**Re: Building Code of Australia Inspection and Reporting Services
Fee Proposal: 152-154 Sydney Road, Fairlight NSW 2094**

Purpose of Report

This report is a high-level commentary that will identify where the proposal is required to comply with the 'Deemed-to-Satisfy (DtS)' provisions of Parts C, D, E & F of the Building of Australia. Where non-compliances are identified, provide upgrading strategies.

Extract from Survey Plan – Prepared by Altitude Surveys dated 07/06/2022

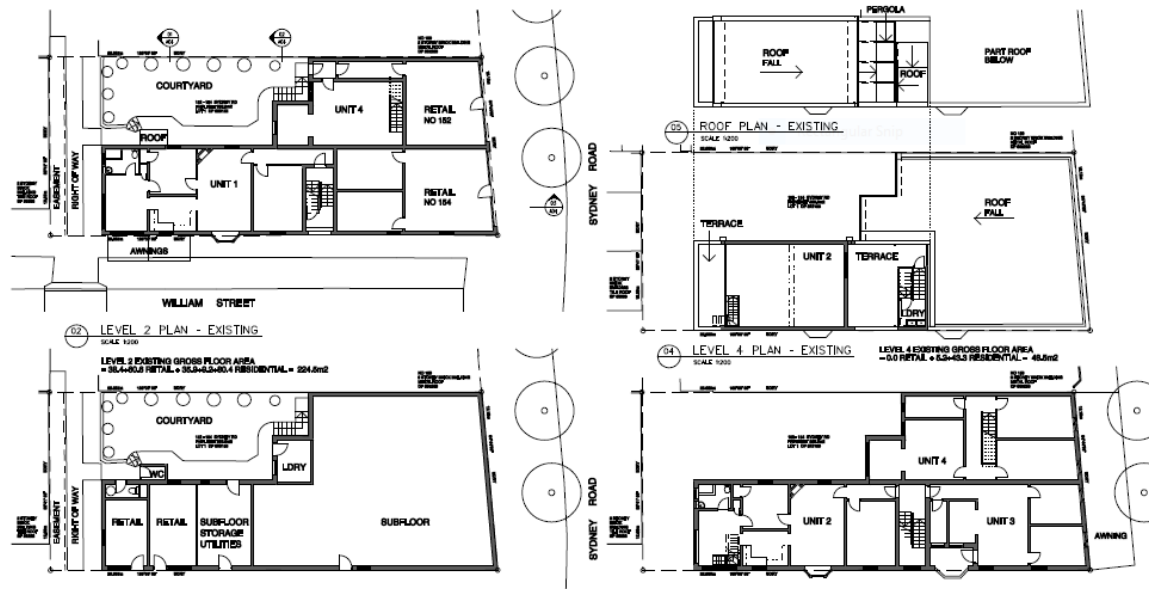
The building is located on the eastern corner of Sydney Road and William Street. The external masonry walls will satisfy the FRL requirements as it is expected that these walls are made up of 270mm cavity brickwork. It is noted that the external wall to the eastern side boundary stands closer than 3m to the boundary and contains a doorway entry for Unit 4. The window and door openings to William Street and Sydney Road elevations do not require protection as the fire source feature is the far side of the Road. Further, it is noted that the existing vertical spandrel separation provided between the windows in the external William Street façade, is less than the required 900mm.

3. Protection of door and window openings along eastern boundary with external drenches – Unit 4.
4. Residential entry doors U1-3 be upgraded to a fire door and frame that is self-closing, tight fitting and achieves a fire resistance of not less than FRL -/60/30.
5. Remove and brick up milk/bread boxes with masonry construction achieving a fire resistance of not less than FRL 90/90/90.
